Re: Comments on the 444 Maple Avenue development

Subject: 444 Maple Avenue Multimodal Transportation Impact Analysis
TIA Review

Re: 444 Maple Avenue, West Vienna Virginia
Letter form D. W Kozera, Inc dated February 19, 2018 P

**Geotechnical Engineering Study,
444 Maple Ave West, Vienna,
Virginia (DWK Contract Number
14107.D)**

Analysis of Current, Proposed and Potential MAC Developments - Dwelling Units per Acre (DU/A)

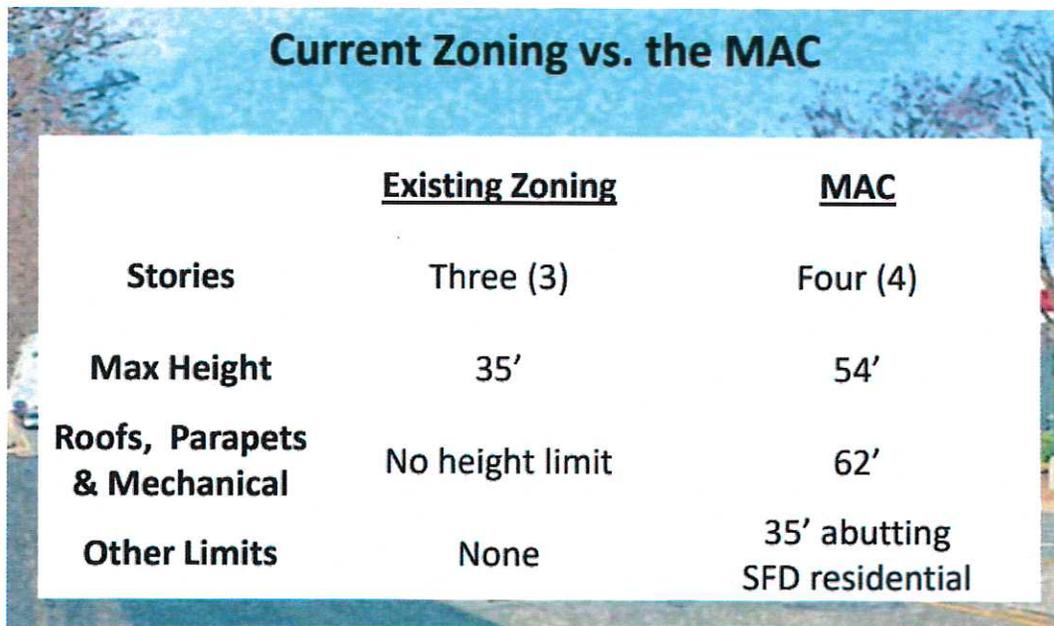
The 2010 census indicates that the Town of Vienna had 5,528 households, and 4,215 families residing in the town. The MAC ad hoc committee’s Analysis of Current, Proposed and Potential MAC Developments chart (Exh. D, shown below) indicates that if development at the 60 dwelling units per acre amount is allowed, the number of households in Vienna would increase by ~1123 households in a very short period of time (1-3 years).

This scale of development—adding 1000 households in 1-3 years along Maple Avenue—is ill advised in light of the current heavy traffic problems along Maple Avenue. Even at the lowest 15 DU/A amount, 455 households would be added along Maple Avenue. These high numbers of additional households concentrated along Maple Avenue indicate a fundamental problem with the MAC—it fails to address town infrastructure and services demands of the rapid development allowed under the MAC.

Figure 1. Slide from PC18-045 - Planning Commission - 7-30-18, page 29/44.

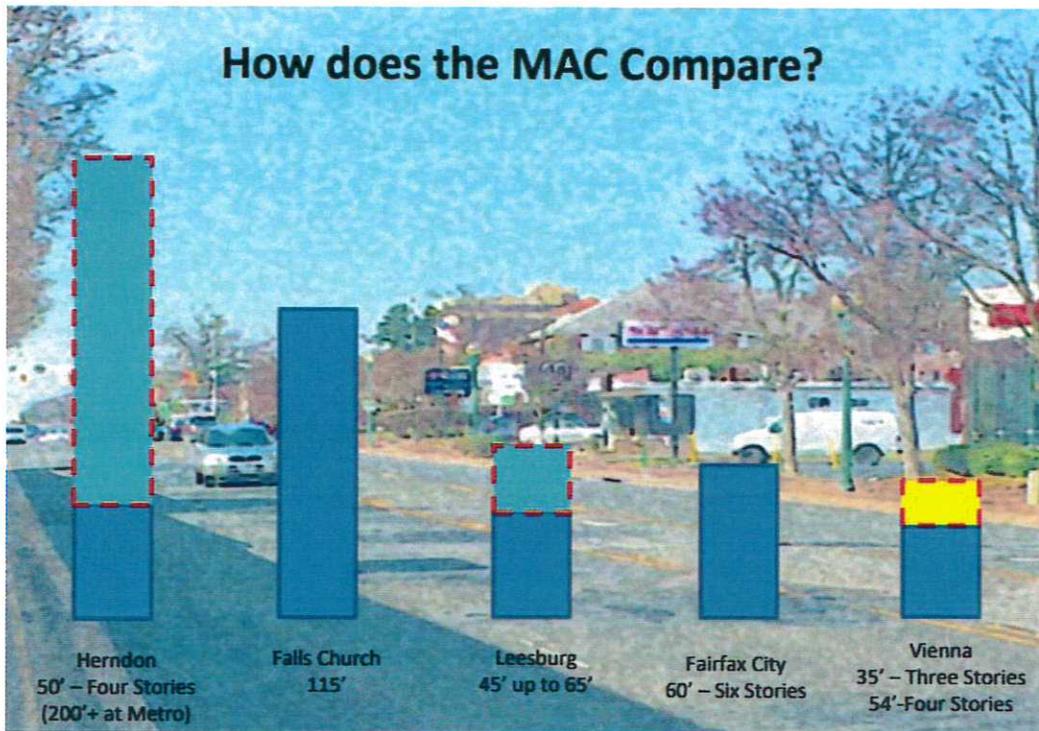
Historically development in Vienna has been limited to 2-3 stories (~35 ft.), which has prevented the blight of Mosaic or Tyson’s-like developments in Vienna (see Figures 1 and 2 below). The proposed 444 Maple Avenue project, whose building’s maximum height would be 62 feet, does not align with Vienna’s small-town identity.

That a 62 foot tall building is acceptable under the MAC is inconsistent with Vienna's "small-town" identity, and indicates a serious flaw with the MAC that should be corrected. The building height analysis in Fig. 2 also shows why neighboring communities like Falls Church—which allows 115 ft. tall buildings—are having problems with over-development and deficient infrastructure. For this reason alone, the 444 Maple Avenue project application should be tabled or denied until the MAC is corrected to align with its stated "small-town" intent.

The Maple Avenue Development Plan needs to be revised to reflect what has kept Vienna's small town feel, a maximum height allowance of 2-3 stories or 35 ft. (including rooftop mechanical devices) (see Fig 1 and 2 above), and a reduced dwelling units per acre allowed (i.e., 5-10, not the current 15-75) so that Vienna's Maple Avenue's traffic and infrastructure problems are not further exacerbated.
